INDESIT company

Model type:
WA8IT

Commercial code:
F026879

n1040235: Restored the fixing of the anterior counterweight with platelets inserted in the tub

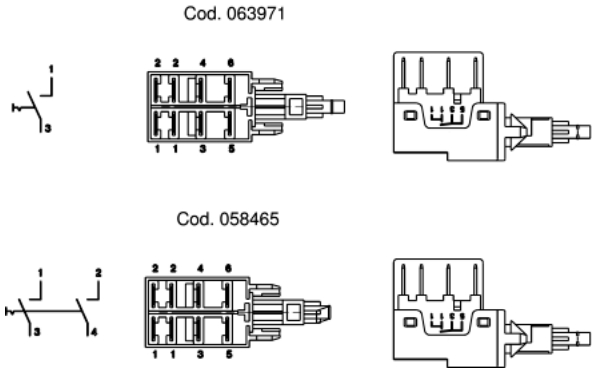
From the 11105.0001 registration number on the washing machines with plastic tubs produced in the Teverola factory, the fixing of the anterior counterweight is restored with platelets inserted in the tub instead of those realised with self-threading screws, the system described in Notice N1040184.
The tubs maintain the same SAT code and are provided with the following particulars:

N° 3 Screws code cod. 014342;
N° 3 Conical washer cod. 055018;
N° 3 Plain washer cod. 034336.

Whenever the necessity may arise on a tub, proceed with diverting the self-threading screws that block the anterior counterweight., as it's compulsory to execute the fixing again avoiding in time a possible loosening and thus the breaking of the tub by utilising the registered screws (cod. 014342), the conical washers (cod. 055018), the plain washers (cod. 034336) and the platelets (cod. 055038).

FIG. 1

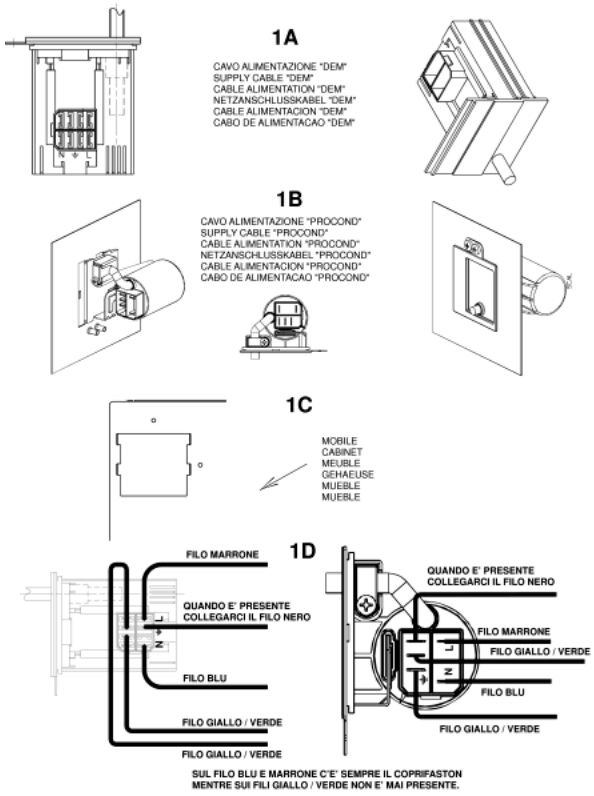
n1040276: Power supply cable + integrally moulded filter.

All appliances produced in the Comunanza (from serial no. 21008.0001), Teverola (from serial no. 21111.0001) and Brembate (from serial no. 21119.0001) factories have been equipped with power supply cables with integrally moulded filter (see fig.1 - 1A and 1B) and new units having a specific opening at the back for fixing the new cables (see fig. 1 - 1C).

The new units, together with the new cables, can be used in place of the premodification ones, by connecting the wiring to the cable, as shown in figure 1 - 1D.
The codes of the new units and of those replaced (ESI - table n1040276fig02), which will be managed until stocks run out, are given below.

IMPORTANT: the fixing / continuity screw is a specific self-scraping screw (code 092348) that ensures earth continuity between the filter and the unit. The same screw must be refitted in order to guarantee machine conformity.

The premodification wirings, are also managed for modified products by making the connection to the terminal block of the new cable as shown in fig. 1 - 1D.
The wiring diagrams given in the Documentation remain unchanged.

n1040279: Heater retaining element bracket and counterweight fixing

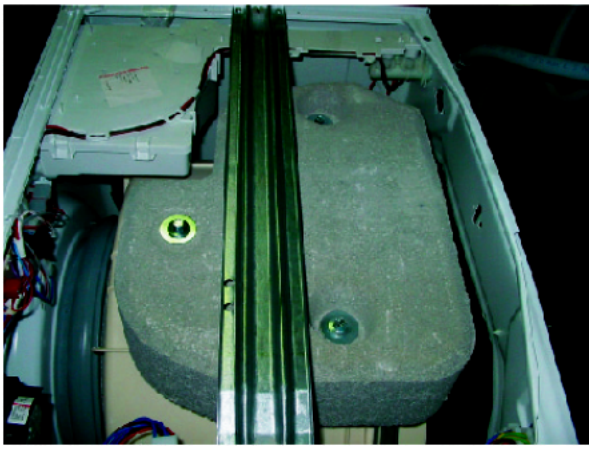
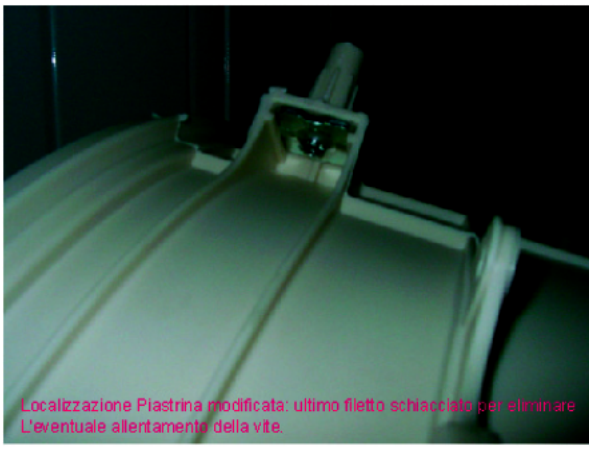
From serial no. 21015.001, a heater retaining element bracket (see fig.3) has replaced the heater retaining element protection Sat code 055036 (see fig.4) on all plastic tanks installed in washing machines produced in the Teverola factory.
The new part (fig. 1A) is fixed to the bowl with a self-tapping screw from the inside outwards and differs from the one used in the Comunanza factory (fig. 1B) in the fixing hole which is not threaded.
In order to reduce the number of parts used, only kit 058523 is managed and which, if used on the Teverola washing machines, must be fixed with a self-tapping screw, instead of metric, after widening the tapped hole with a suitable drill bit.
When inserting the heater retaining element, particular care must be taken so that it is fitted correctly (Fig. 3).
The plastic tanks to be arranged for the guide have the same Sat code as those with the protection.

>From serial no. 21121.0001, the counterweight Fig. 2B with outlet increased by 5 mm in the centre has replaced the previous counterweight Fig. 2A.
The new counterweight (fig. 5) is fixed using three M8 X 63 mm screws with washer code 092016 (see fig. 8) and three plates with the last thread flattened (fig. 6) to prevent accidental loosening of the screw.
All the plates code 055038 in stock in the Centralised Warehouse have been replaced and can also be used on premodification appliances.
The modified counterweight has the same Sat code as the premodification item (066615) that will be managed until stocks run out.
The new counterweight must be assembled using the new screws and plates (see fig. 7).
Both counterweights can be employed necessarily using the following fixing parts which are specific for each type of counterweight:

Fixing parts for premodification counterweight (see fig. 9):
3 pieces code 055019 - Screw M8 X60 mm;
3 pieces code 055018 - Conical washer;
3 pieces code 034336 - Flat washer;

Fixing items for modified counterweight:

3 pieces code 092016 - Screw M8 X 63 mm with washer;
3 pieces code 055038 - Plate with last thread flattened;

FIG. 1

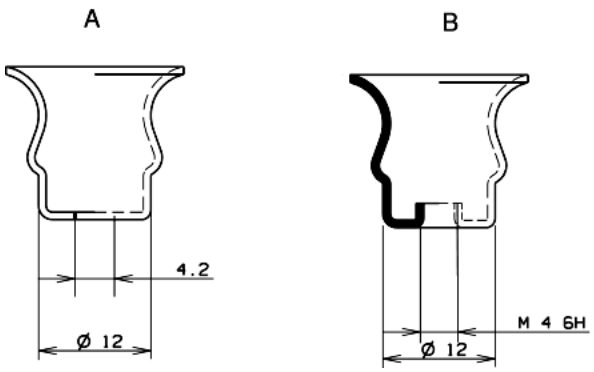
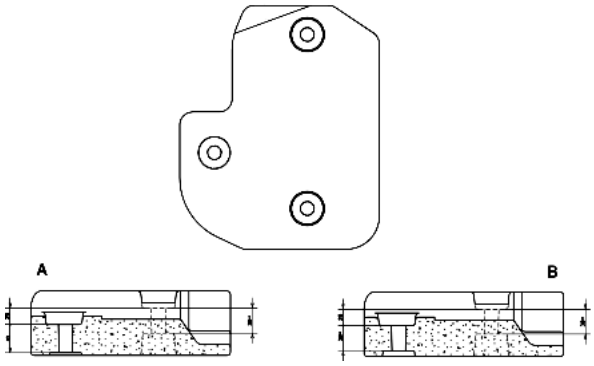
Particolari per il fissaggio del contrappeso modificato:
N° 3 pezzi del cod. 055038 – Piastrina con ultimo filetto schiacciato per evitare l'eventuale allentamento del perno.

Localizzazione Piastrina modificata: ultimo filetto schiacciato per eliminare L'eventuale allentamento della vite.

Particolari per il fissaggio del contrappeso modificato:
N° 3 pezzi del cod. 092016 – Vite M8X63 mm con rondella incorporata.

Particolari per il fissaggio del contrappeso premodificato:
N° 3 pezzi del cod. 055019 – Vite M8X60 mm,
N° 3 pezzi del cod. 055018 – Rosetta conica,
N° 3 pezzi del cod. 034336 – Rondella piana.

FIG. n1040305fig01

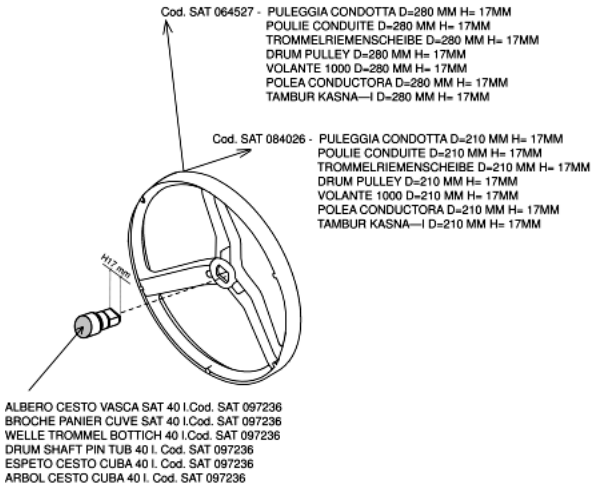
n1040305: Introduction of EVO on LB2000 washing machines produced at Teverola.

Since August 2003, the following modifications are gradually being made to the oscillating unit on 2000 range models produced in the Teverola factory:
Gradual use of the EVOII 40 litre plastic bowl (code 097236) which differs to the previous LB2000 version, for the following characteristics:
1) Assembled with basket and welded bowl lid;
2) Elimination of detergent recovery tube hole (where provided);
3) Diameter 30 cm opening instead of 28 cm;
The last two numbers of the Industrial Code (given on the rating plate) of the models relevant to this system will be 30 (e.g. 46268790030)

·Eeproms - The new software for the 40 litre EVO washing machines can also be used on premodification appliances; it is managed with the same Sat codes as the previous software, which is being immediately replaced as the new models enter into production.
·Pulleys - The use of a single 40 litre bowl assembly in Assistance involves management of the pulleys used in production (097268 and 097267) and also those required for creating the various combinations (see fig. n1040305fig.01):

Code 064527 - Pulley D=280mm H=17 mm;
Code 084026 - Pulley D=210mm H=17mm.

NB: From serial no. 31103.0001, all EVO appliances are equipped with a 40 litre bowl with H=15 mm drum cross shaft which will be managed with the same SAT code (097236) as the 40 litre bowl with H=17 mm shaft until stocks last.
To create the various combinations, the following pulleys are required:

Code 097268 - Pulley D=280mm H=15 mm;
Code 097267 - Pulley D=210mm H=15mm.
Exceptions to this are models W93UK (23330) and W103UK (23334) which are equipped with a 46 litre bowl; therefore if the bowl needs replacing code 096198 with 20 mm pulley cross shaft must be used.
In production, pulley code 064527 (diameter D= 280 mm and central hole H= 17mm) is used; therefore, when replacing the bowl, code 097269 (diameter D= 280 mm and central hole H= 20mm) must be used.
